**Re: Ameren Missouri
Labadie Power Station
Response to O'Brien & Gere Final Dam Safety Assessment of CCW Impoundment**

RE: Ash Pond Stability Recommendations
Labadie Power Station

Labadie Power Station
 Steady Seepage, Full Reservoir
 Cross-section 5

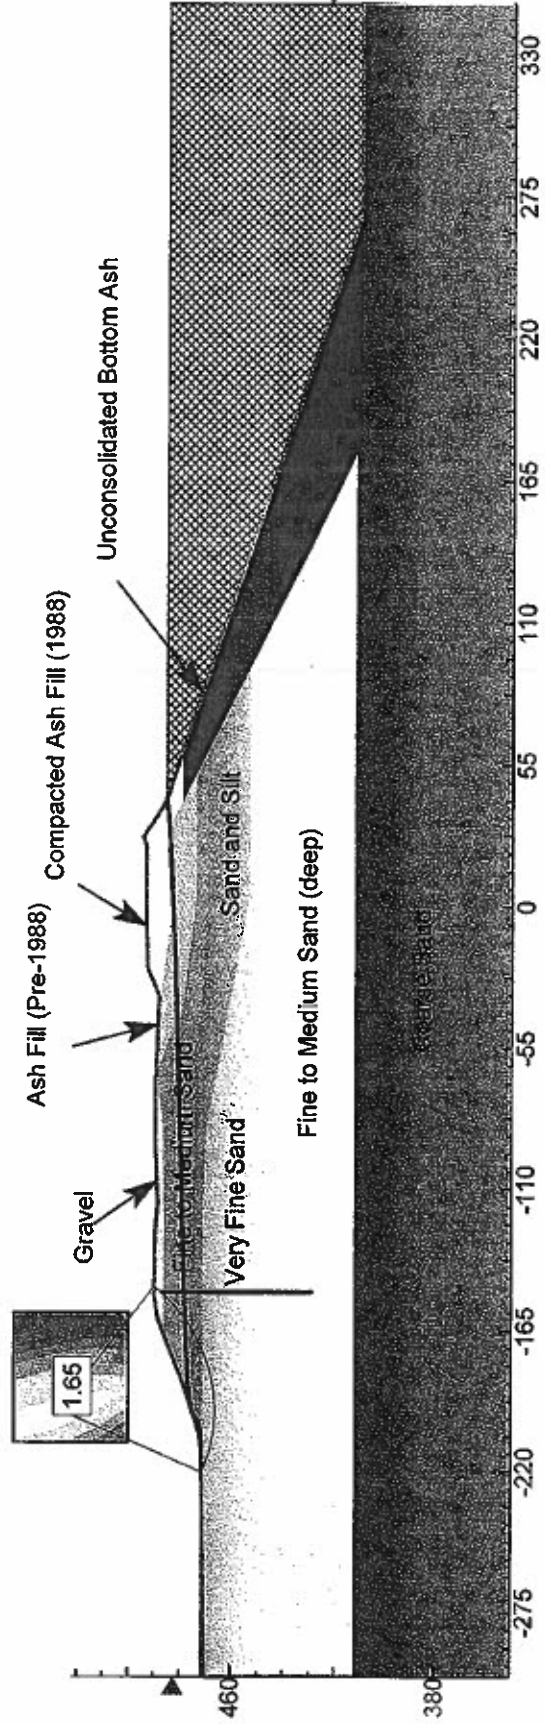
“Additional studies – no additional studies may be needed. The input for cross section 5 should be provided.”

Response – The result of stability analysis of cross section 5 for full pond, steady-state seepage, and long-term (drained) shear strength properties is depicted graphically and attached. Shown on the figure are the long-term shear strength properties used in the analysis. The analysis limited the search for failure surfaces to include “deep” failures surfaces or slope failures that would require significant effort to repair.

Location: Labadie Power Plant	Position: X: 726283.89 ft, Y: 992395.37 ft	Ground level: 492.49	Test no: P-3
Project ID: 2010012488	Client: AmerenUE	Date: 6/23/2010	Scale: 1 : 42
Project: Ash Pond Stability Analysis		Page: 1/1	Fig: 3-3
Revised 8/2/2011		File: P-3.cpd

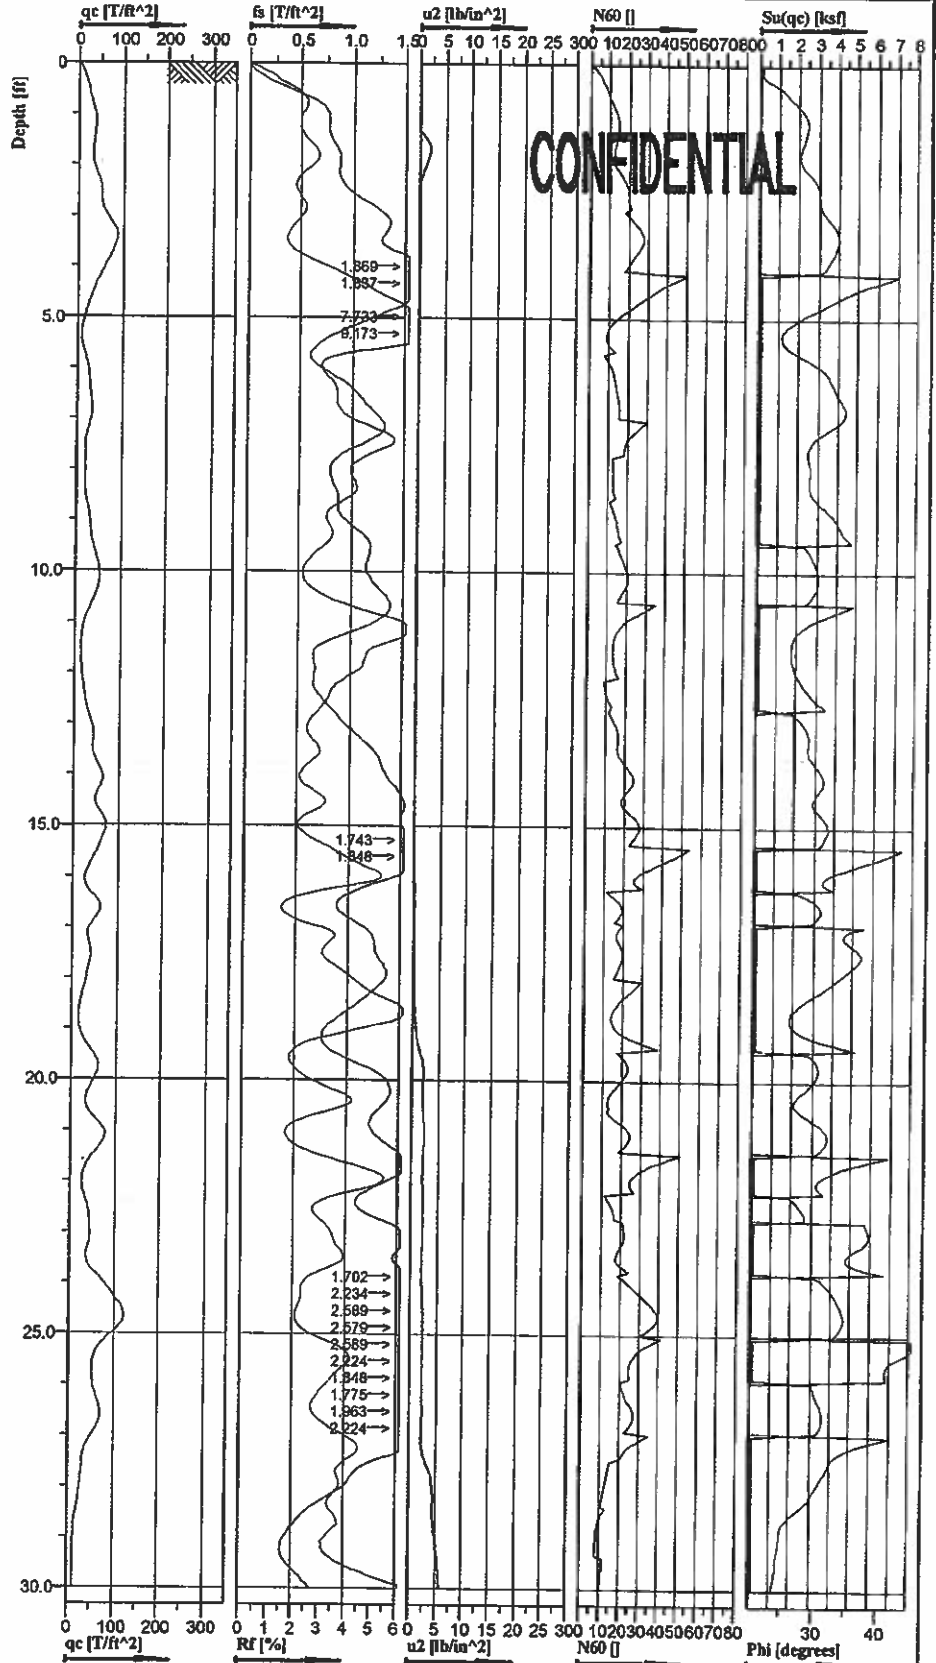
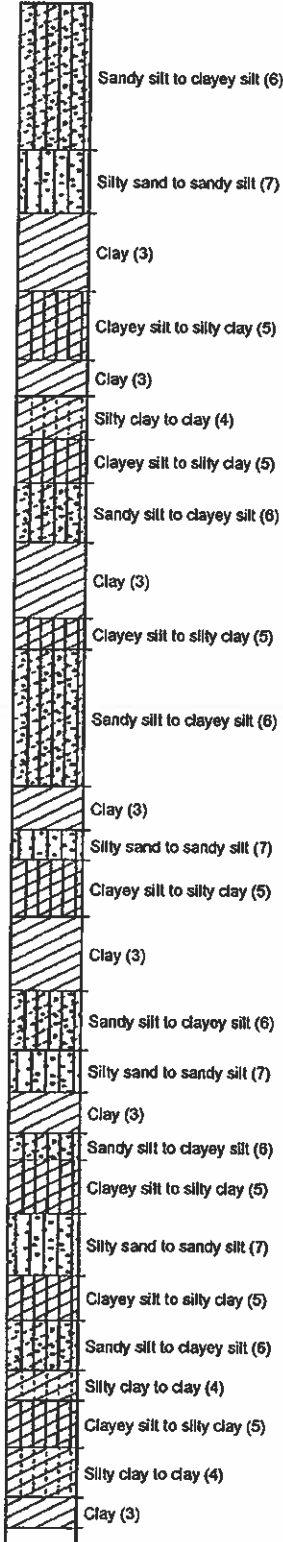
“Additional studies – no additional studies may be needed. However, an explanation as to why the water level readings in Soundings P-3 and P-4 were not used in the analysis should be provided, and/or the slope stability analyses should be re-run using the data from Sounding P-4 (apparent worst-case scenario).”

Response - The water levels shown on soundings P-3 and P-4 are at elevation 476.5 and 487.3, respectively. These soundings were conducted in the crest of the embankment for the Fly Ash Pond which is lined with HDPE. The normal water level in the fly ash pond is estimated between elevations 475 to 480 feet based on weekly inspections. In the slope stability analysis presented in the November 2010 report it was assumed that the normal pool level was at elevation 484 feet,

While analyzing the CPT soundings it was concluded that the elevated pore pressures were the result of induced strains caused by advancing the CPT cone through unsaturated strata or due to thin, wet coarse grained strata bounded by impervious fine grained strata. Our conclusion that the water levels shown on the logs are not a true groundwater level was supported by the following observations:

- The water levels shown on the soundings are generally higher than the normal pool water level, and there is no higher topographic tributary area upstream to support or supply this groundwater elevation

- The measured tip pressure and sleeve friction do not support saturated soil behavior for the type of soil observed, above the assumed water level used in the analysis. The measured tip pressure at a depth of approximately 29 feet was lower in Soundings P-3 and P-4 than what was measured in the overlying strata. This behavior was also observed in Soundings P-2 and P-10

- The HDPE liner is generally assumed in good condition, but even for large punctures or tears in the liner seams, it is doubtful that a potential seepage source entry would have sufficient size to allow the volume of water necessary to elevate the water level to those shown in Soundings P-3 and P-4. In addition, the upstream slope is buttressed with a considerable thickness of relatively impervious fly ash

- Soundings P-2 and P-10 which were advanced approximately 20 feet past the termination depths of P-3 and P-4 and into the underlying foundation strata show the water level much deeper between elevations 464.07 and 464.79. The potential source of seepage is much closer at sounding location P-2 because the upstream slope is not buttressed with relatively impervious fly ash.

The water levels shown on CPT soundings P-3 and P-4 are assumed erroneous and have been removed from the revised logs which are attached.
